**Merged Document Report****Application No.: PL8820**

| Record Type : | PLAT |

PRELIMINARY PLAT OF
**THE LAKES NORTHWEST
UNIT 3**

STORM WATER QUALITY MANAGEMENT PLAN FOR THE PRELIMINARY PLAT OF

1 TYPE L-A - 50-FT STREET CROSS SECTION - PROPOSED
PLAT 1 SCALE: NTS

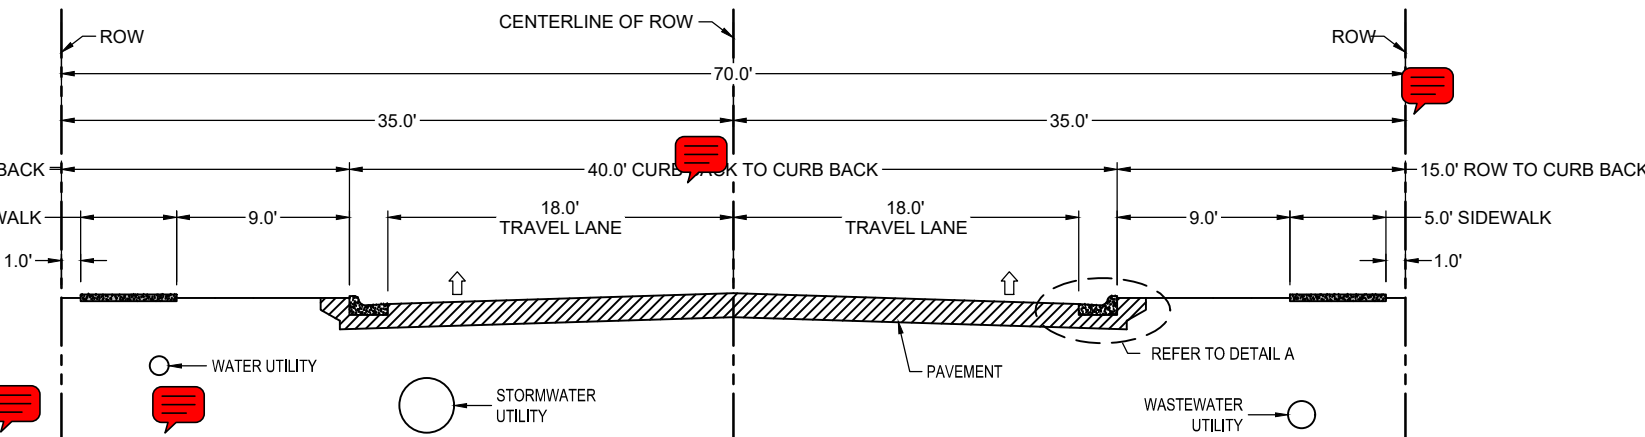
| Comment ID | Page Reference | Annotation Type | Author : Department | Status | Review Comments | Applicant Response Comments |
|------------|----------------|-----------------|---------------------|--------|--|-----------------------------|
| 20 | P001 | Note | Caleb Wong : STREET | Closed | PW STR: Per IDM Table 6.3.5H, the road section cross-slope from the crown to the gutter shall be a consistent 2% minimum. | |
| 22 | P001 | Note | Caleb Wong : STREET | Closed | PW STR: Per IDM table 6.3.5H, the treated subgrade and flexible base shall extend at least 2 feet beyond the back of curb. | |

1 TYPE L-A - 70-FT STREET CROSS SECTION - PROPOSED
PLAT 1 SCALE: NTS

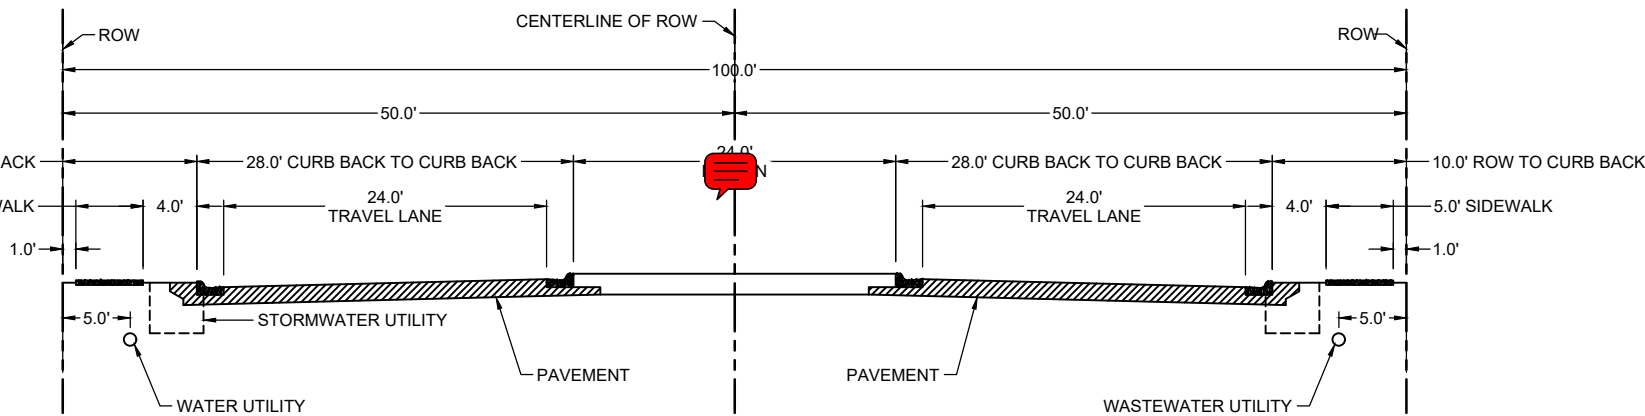
| Comment ID | Page Reference | Annotation Type | Author : Department | Status | Review Comments | Applicant Response Comments |
|-------------------|-----------------------|------------------------|----------------------------|---------------|--|------------------------------------|
| 9 | P001 | Note | Alex Harmon : DS | Closed | 10/1/25 UPDATE: Traffic/Streets to comment on street cross section/medians. 70 ft ROW is not typical for street classification L-A per IDM 6.2.1. | |

| Comment ID | Page Reference | Annotation Type | Author : Department | Status | Review Comments | Applicant Response Comments |
|------------|----------------|-----------------|---------------------|--------|--|-----------------------------|
| 18 | P001 | Note | Caleb Wong : STREET | Closed | PW STR: Based on the typical sections, Solitude Lake Dr will have a median due to it having a 70-ft ROW. What is the reason for the median? | |

| Comment ID | Page Reference | Annotation Type | Author : Department | Status | Review Comments | Applicant Response Comments |
|------------|----------------|-----------------|---------------------|--------|--|-----------------------------|
| 43 | P001 | Note | Caleb Wong : STREET | Closed | PW STR: Per Table 6.2.2.A, a 70-ft ROW is not a typical ROW width for a L-1A/B street. In addition, Table 6.2.2.A does not implicitly allow medians on local streets. PW does not accept the medians but will hold the Engineer responsible for the engineering design and judgement of the medians. | |
| 46 | P001 | Note | Caleb Wong : STREET | Closed | PW STR: Update street typical sections to reflect the removal of the medians as called out in the applicant's response | |

1 TYPE L-B - 100-FT STREET CROSS SECTION - PROPOSED (PRIVATE)
PLAT 1 SCALE: NTS

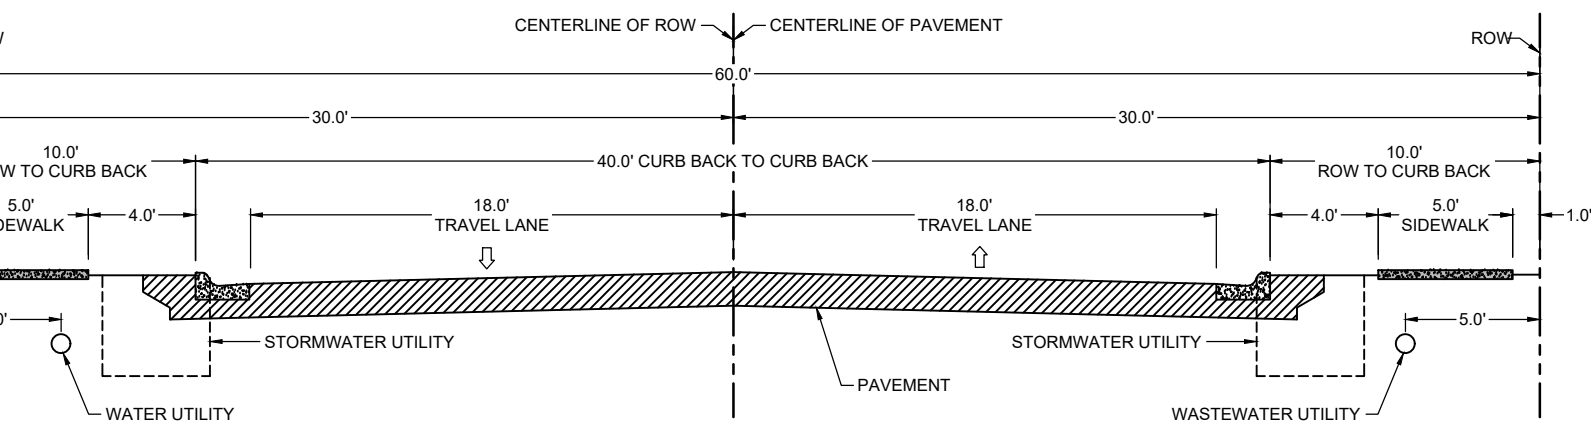
| Comment ID | Page Reference | Annotation Type | Author : Department | Status | Review Comments | Applicant Response Comments |
|-------------------|-----------------------|------------------------|----------------------------|---------------|--|------------------------------------|
| 10 | P001 | Note | Alex Harmon : DS | Closed | 100 ft ROW is not typical for street classification L-B per IDM 6.2.1. | |

1 TYPE C1 - 60-FT STREET CROSS SECTION - PROPOSED
PLAT 1 SCALE: NTS

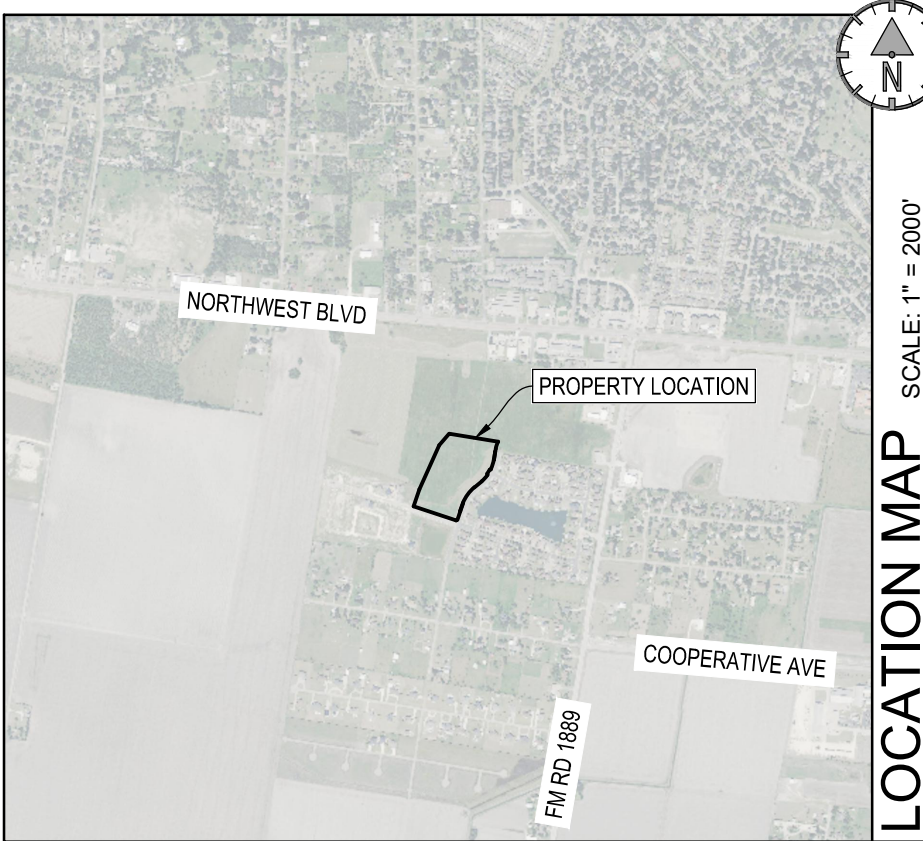
| Comment ID | Page Reference | Annotation Type | Author : Department | Status | Review Comments | Applicant Response Comments |
|------------|----------------|-----------------|---------------------|--------|--|-----------------------------|
| 40 | P001 | Note | Mina Trinidad : DS | Closed | C1 collector street located within development | |

| Comment ID | Page Reference | Annotation Type | Author : Department | Status | Review Comments | Applicant Response Comments |
|------------|----------------|-----------------|---------------------|--------|--|-----------------------------|
| 19 | P001 | Note | Caleb Wong : STREET | Closed | PW STR: Based on City GIS, W. River Rd has a ROW width of 60 ft but is classified as a local, not a C1. Urban Transportation Plan calls out a C1 road through proposed development. Please coordinate with Public Works Traffic Department to confirm if proposed street layout and nomenclature match any proposed or revised Urban Transportation Plan. | |

UTILITY PLAN FOR THE PRELIMINARY PLAT OF

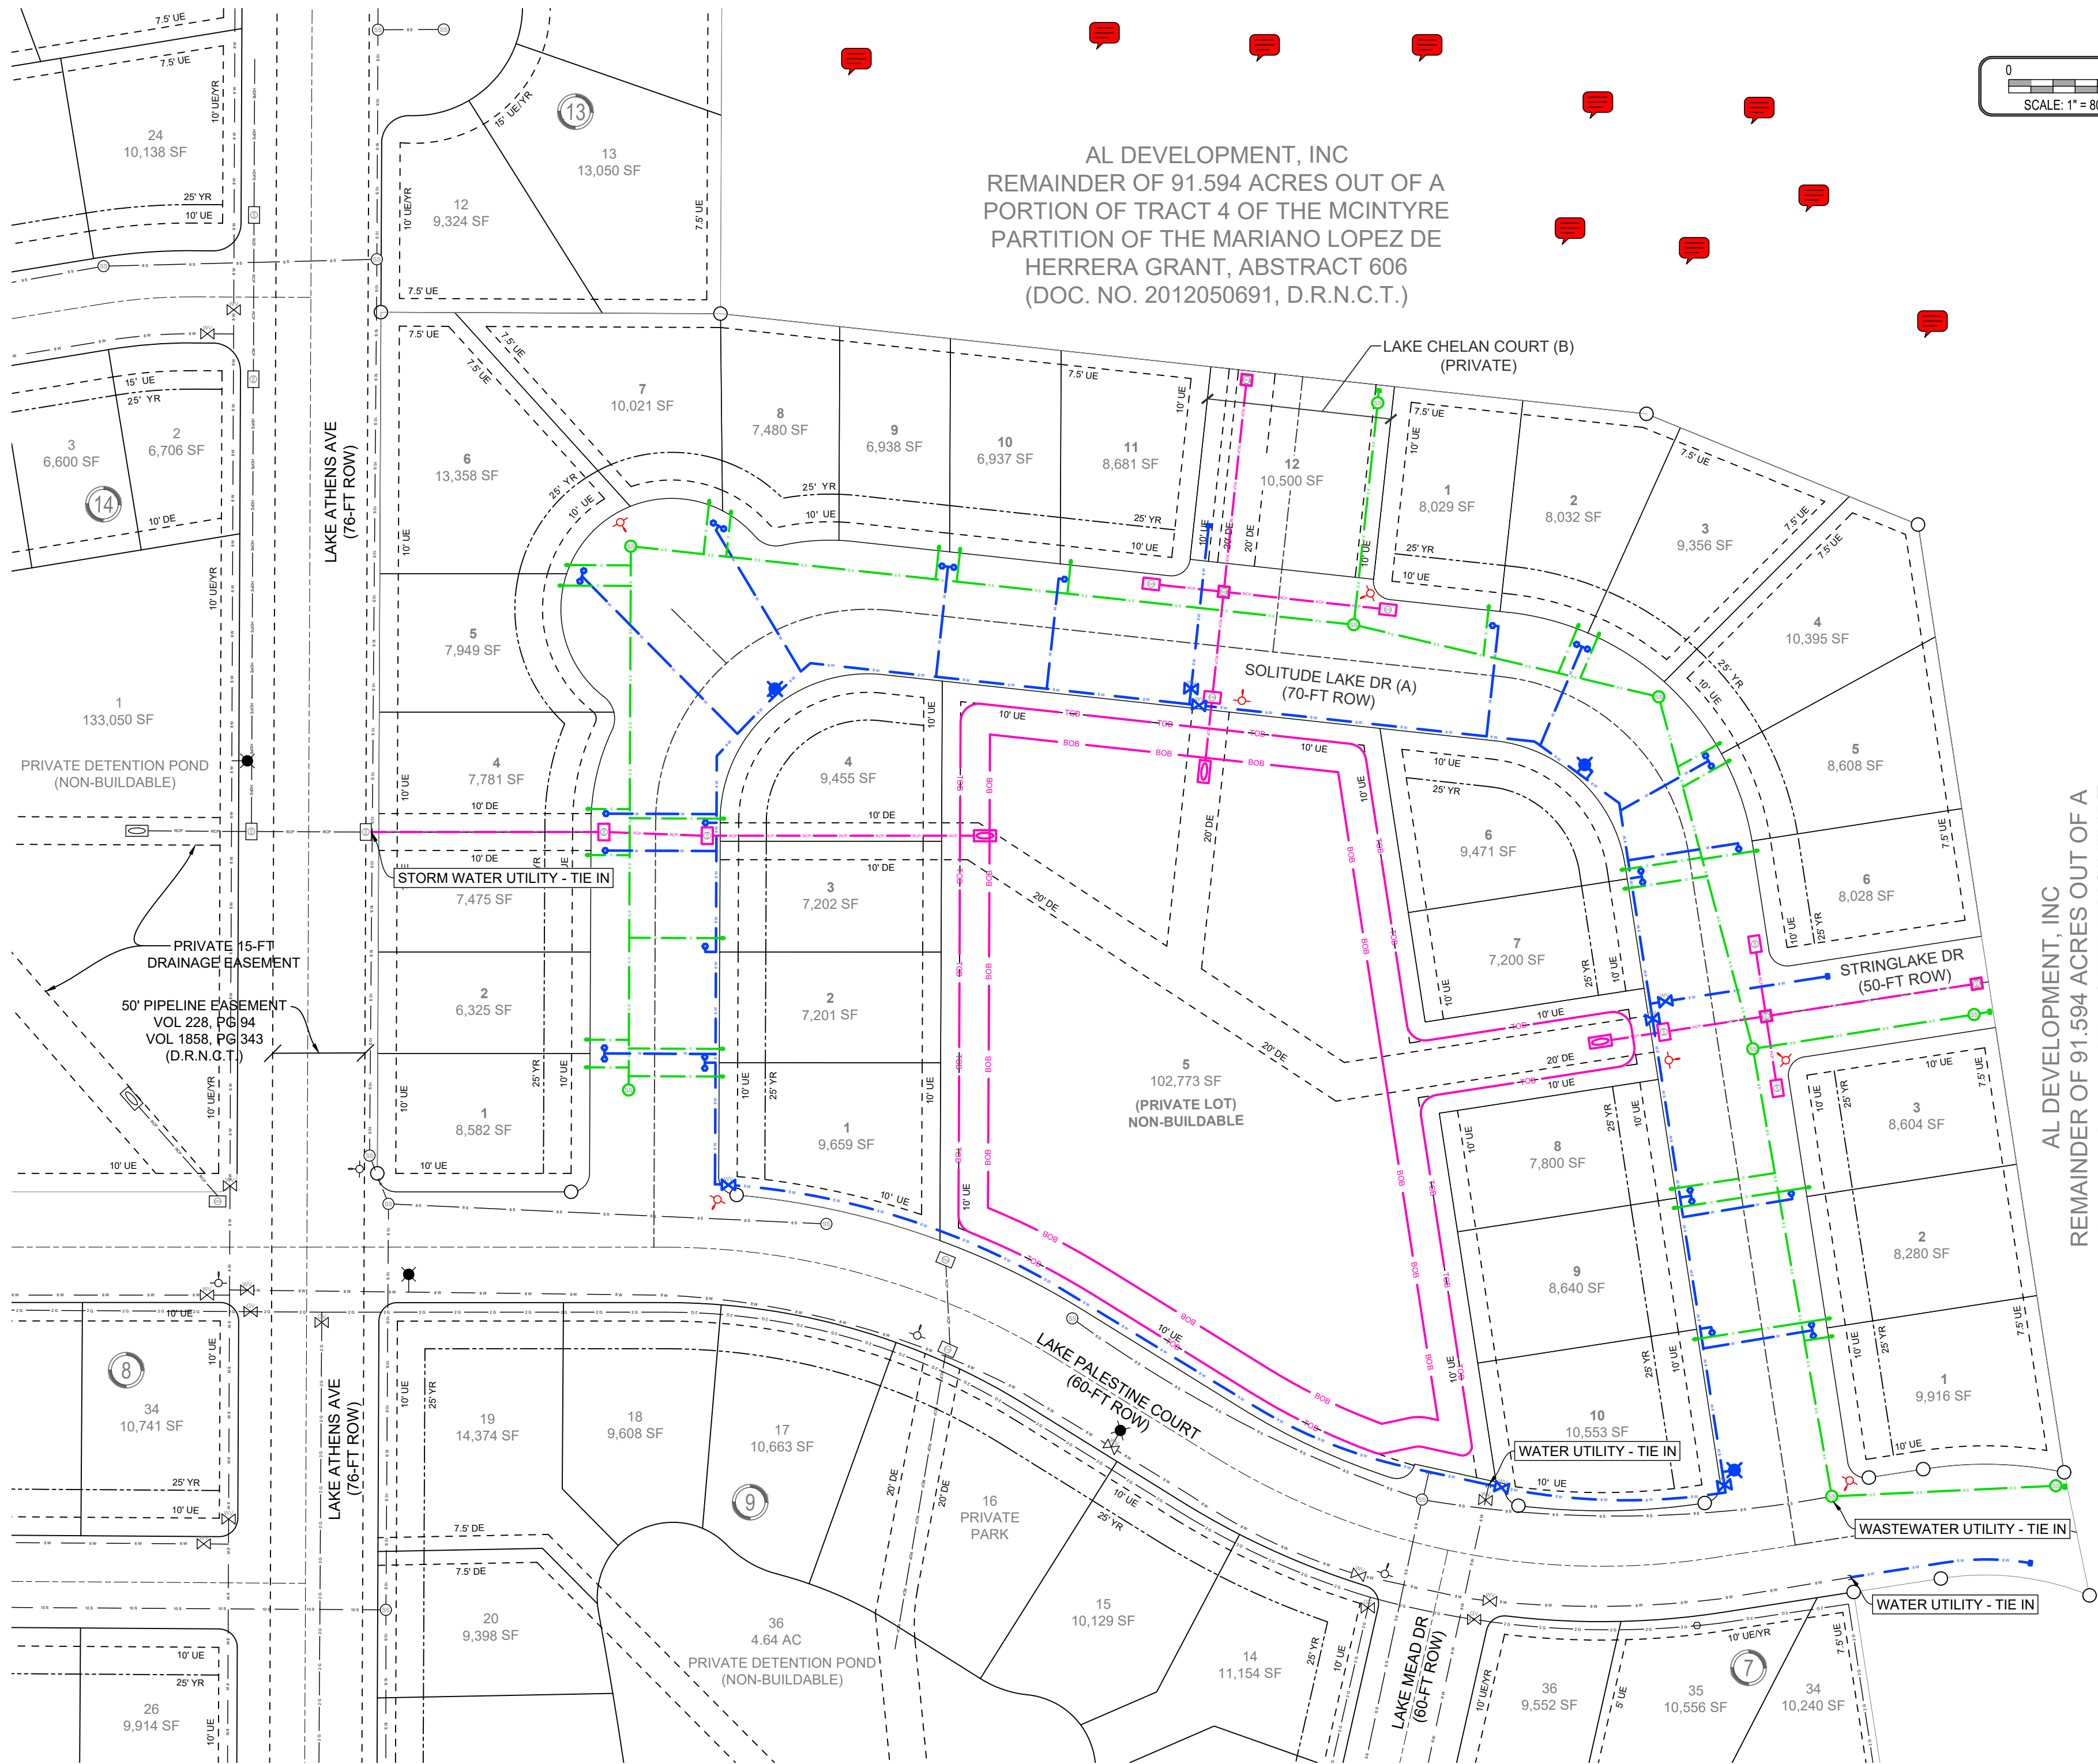
| Comment ID | Page Reference | Annotation Type | Author : Department | Status | Review Comments | Applicant Response Comments |
|------------|----------------|-----------------|---------------------|----------|---|-----------------------------|
| 28 | U002 | Note | Mina Trinidad : DS | Closed | Nueces Electric Cooperative (NEC): This subdivision is in a single certified area to Nueces Electric Cooperative. NEC will be providing service to this subdivision and will request a 10' EE on the plat from Munoz Engineering replacing the 10' UE. | |
| 29 | U002 | Note | Mina Trinidad : DS | Closed | Nueces Electric Cooperative (NEC): From the notes provided by Caleb Wong with the CCW, NEC will install all streetlight poles inside the 10' EE (Electrical Easement) with a 6' streetlight arm. The existing proposed plans show the streetlights to be installed along the curb and inside the public right-of-way. | |
| 30 | U002 | Note | Mina Trinidad : DS | Closed | Requesting coordination about the UE on the subject plat, with AEP and NEC. | |
| 31 | U002 | Note | Mina Trinidad : DS | Closed | (Informational) AEP Texas Distribution requested 10' UE of the ROW's to be a 5' EE and 5' UE on the final plat. (Comment was then redacted by George Guerra - AEP) | |
